DART AEROSPACE LTD	Work Order:	129307
Description: Crosstube Assembly	Part Number:	D206-667-243
Inspection Dwg: D206-667-243 Rev: C		Page 1 of 2

DESIGN	07	DART AEROSPACE LTD	
DRAWN	RF	HAWKESBURY, ONTARIO, CANADA	
CHECKED	07	DRAWING NO. D206-667-243	REV. C
MFG. APPR.	07	TITLE	SHEET 2 OF 4
APPROVED	07	CROSSTUBE ASSY (206L HIGH AFT)	SCALE
DE APPR.	07		NTS
DATE	08.11.06	COPYRIGHT © 2006 BY DART AEROSPACE LTD THIS DOCUMENT IS PRIVATE AND CONFIDENTIAL AND IS SUPPLIED ON THE EXPRESS CONDITION THAT IT IS NOT TO BE USED FOR ANY PURPOSE OR COMMUNICATED TO ANY OTHER PERSON WITHOUT WRITTEN PERMISSION FROM DART AEROSPACE LTD.

DRAWING NO. D206-667-243	TITLE CROSSTUBE ASS'Y (206L HIGH AFT)	REV. C	DART AEROSPACE LTD ENGINEERING ORDER		D.E.O. NO. D206-667-243-C-1	SHEET NO. SHEET 1 OF 1	SCALE NTS
DRAWN <i>q</i>	CHECKED <i>ASS</i>	MFG. APPR. <i>RB</i>	APPROVED <i>MP</i>		DE APPR. <i>#</i>		
DATE 11.07.15	DATE 11.07.20	DATE 11.07.21	DATE 11/07/21		DATE 11.07.21

REPLACE MAGNOBOND WITH PROSEAL.

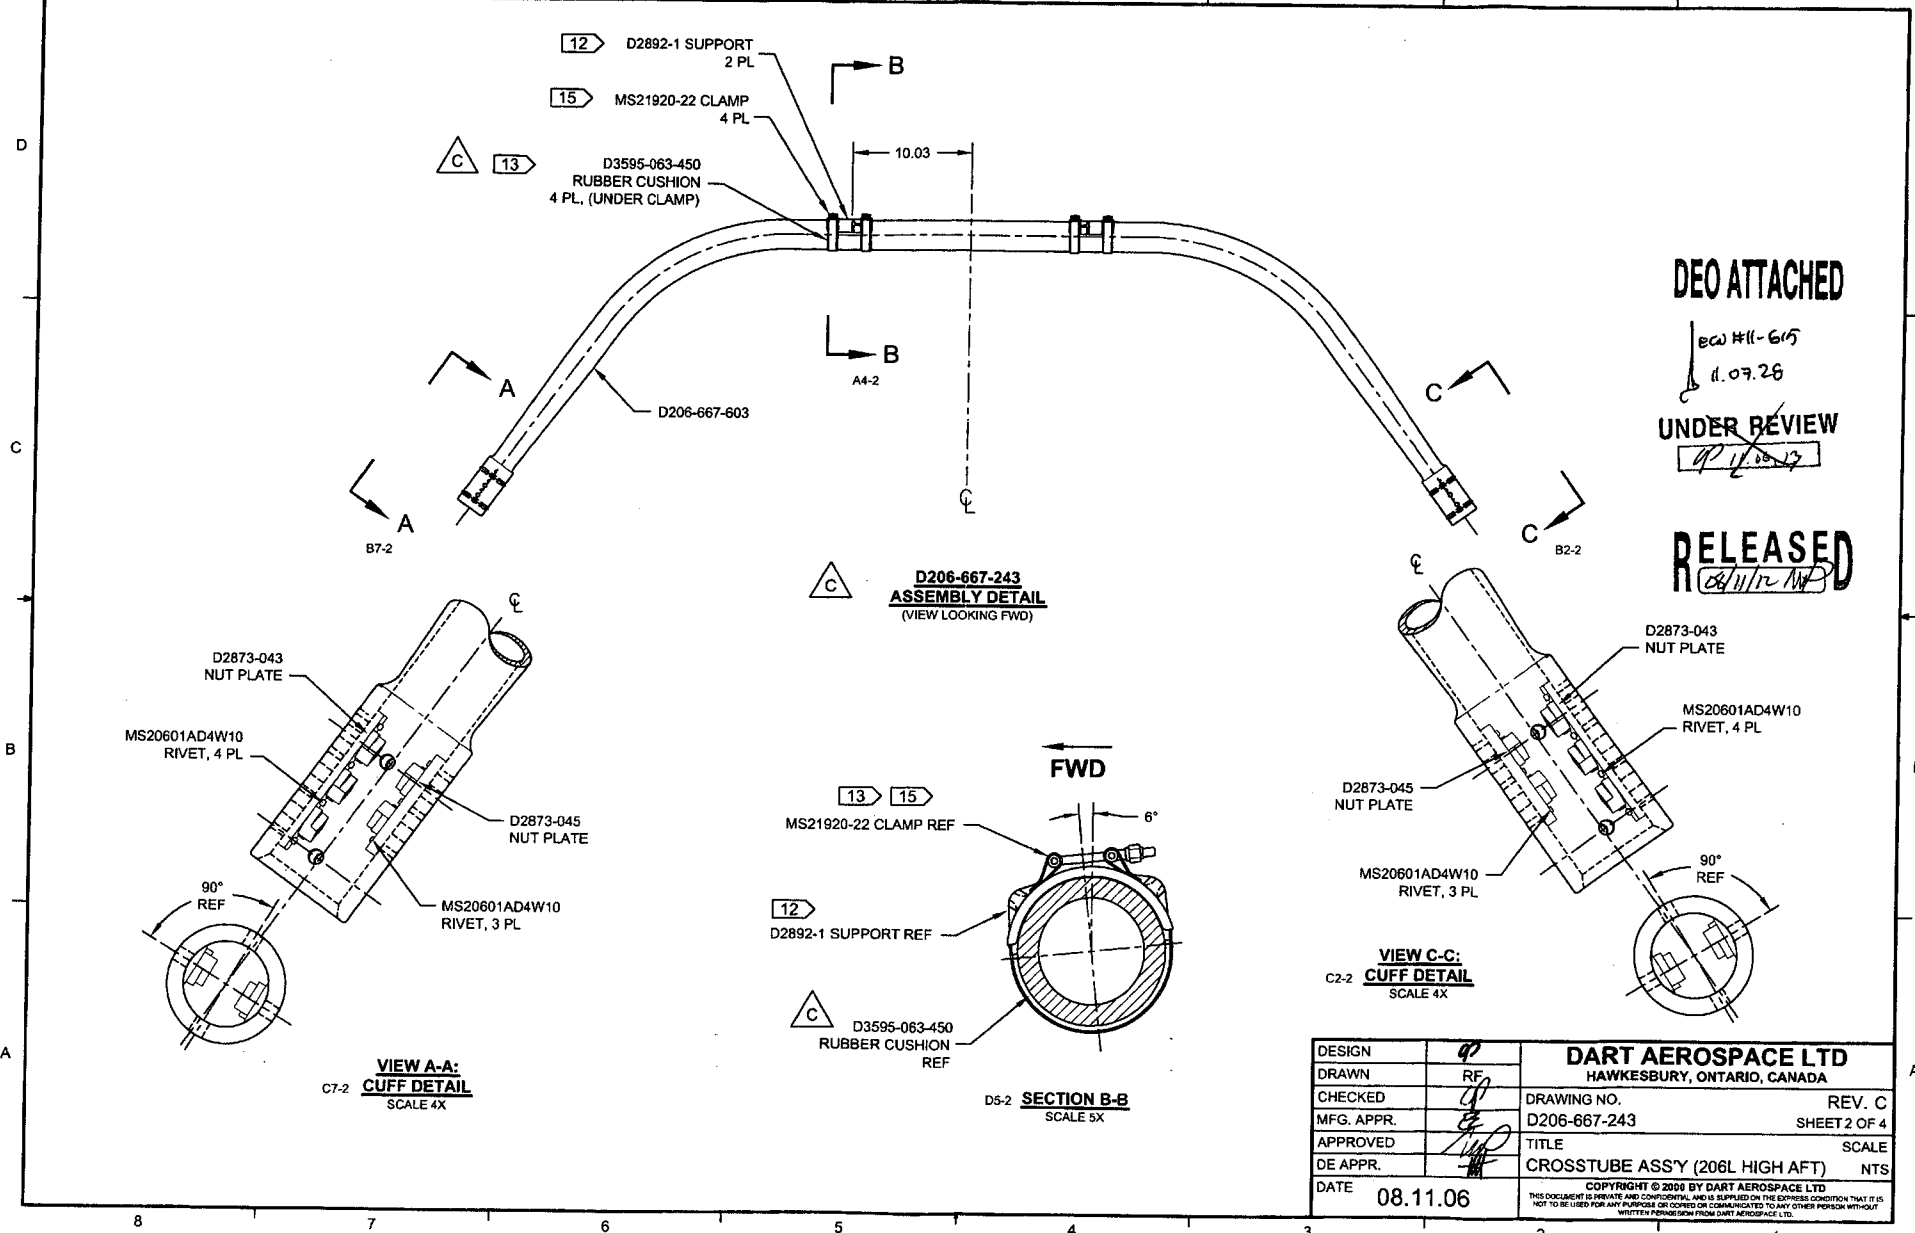
9	A/R	MAGNOBOND 6398	ROCKWELL SPECIFICATION RBO-120-023 ADHESIVE (TEXTRON/BELL SPEC. 299-947-100, TYPE II, CLASS 2 ADHESIVE)
---	-----	----------------	---

- 12) INSTALL D2892-1 SUPPORT USING 0.03" TO 0.06" THICK LAYER OF MAGNOBOND 6398 PER QSI 015. LET CURE FOR 12 HOURS AFTER INSTALLATION AND PRIOR TO PACKAGING.
- 15) TORQUE CLAMPS 80 TO 100 IN-LB. ENSURE AT LEAST 1.5 THREADS SHOWING IN SAFETY AND THAT NUT HAS NOT BOTTOMED-OUT AFTER TORQUING.

Item	Qty -243	Part Number	Description
9	A/R	PROSEAL 890 B-2	SEALANT, AMS-S-8802 CLASS B-2

- 12) TO INSTALL D2892-1 SUPPORT: ABRABE MATING SURFACE OF SUPPORT AND CROSSTUBE WITH 180-GRIT SANDPAPER AND REMOVE RESIDUE WITH MEK (OR EQUIVALENT). APPLY A 0.04" TO 0.07" THICK LAYER OF PROSEAL 890 CLASS B-2 (OR AMS-S-8802 CLASS B-2) SEALANT TO MATING SURFACE OF SUPPORT.
- 15) TORQUE CLAMPS 80 TO 100 IN-LB. ENSURE AT LEAST 1.5 THREADS SHOWING IN SAFETY AND THAT NUT HAS NOT BOTTOMED-OUT AFTER TORQUING. **PRIOR TO PACKAGING, RE-CHECK TORQUE ON CLAMPS AFTER PROSEAL 890 SEALANT HAS CURED FOR 72 HOURS.**
